ADDENDUM NO. 2

Colton MS Pavilion Building Addition

Colton Joint Unified School District
1212 Valencia Drive
Colton, CA 92324

DSA #04-123039

4

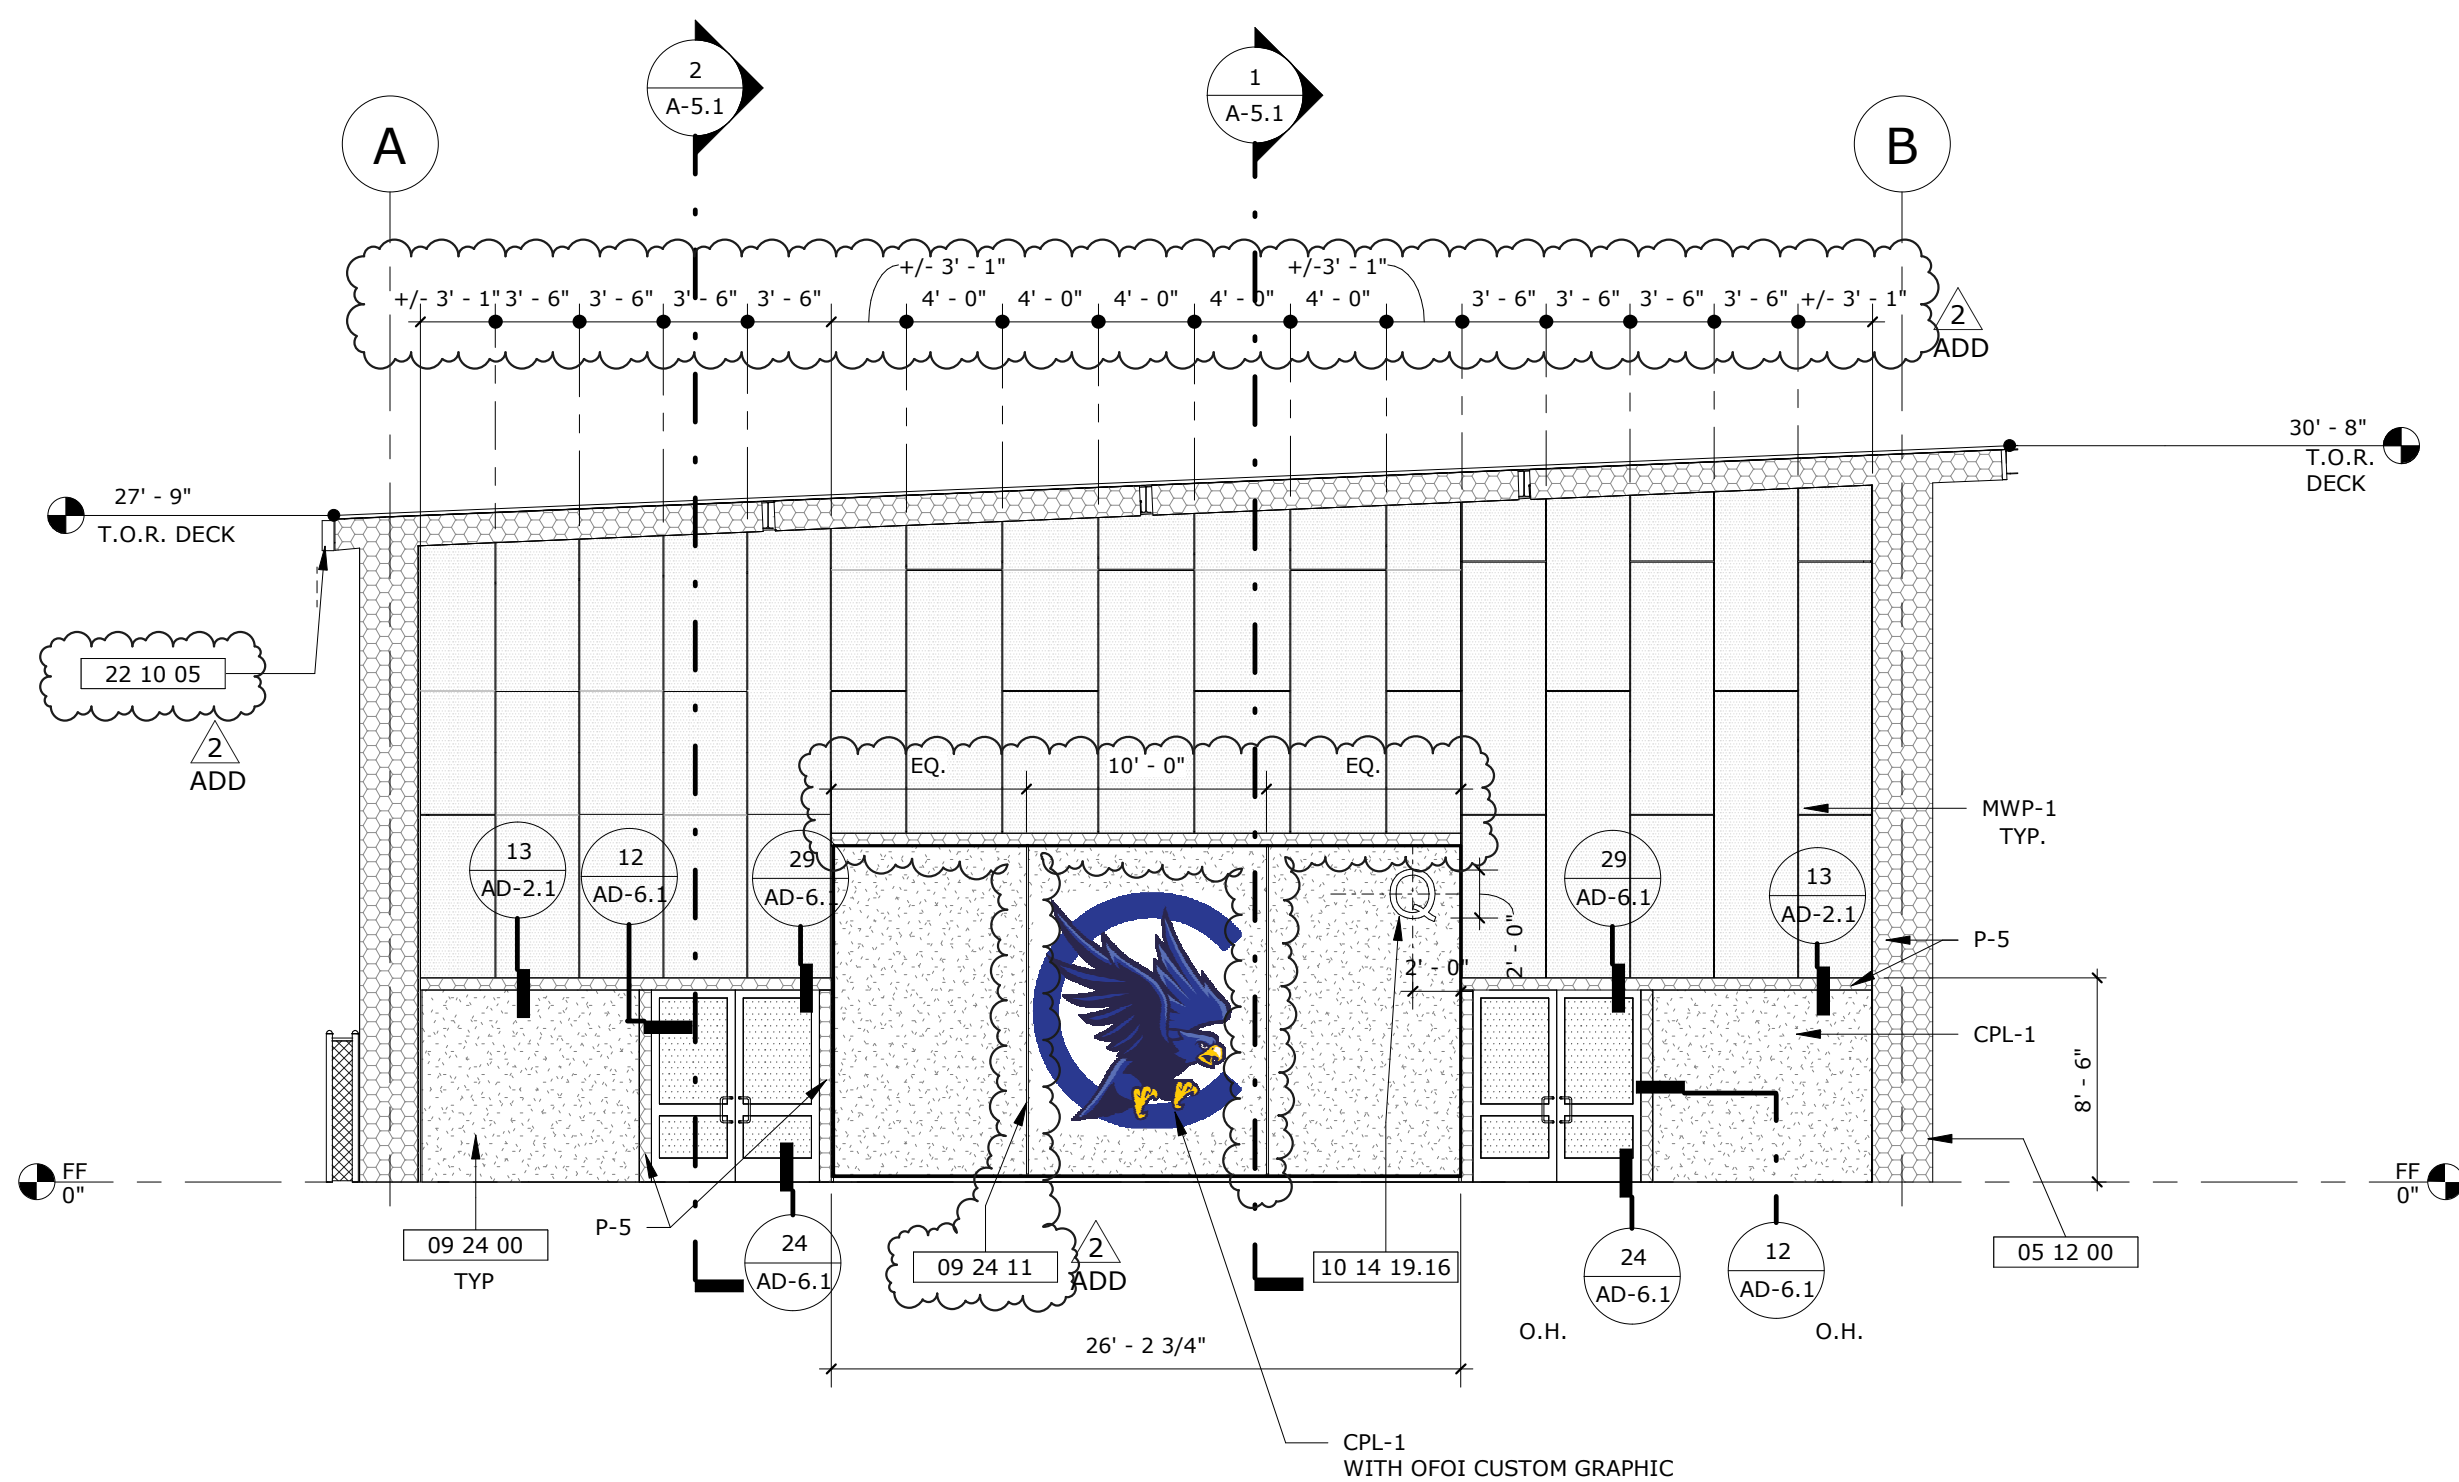
| 2.6.1 | Revised Keynotes and Details 1, 2, 3 & 4 per clouded areas. |
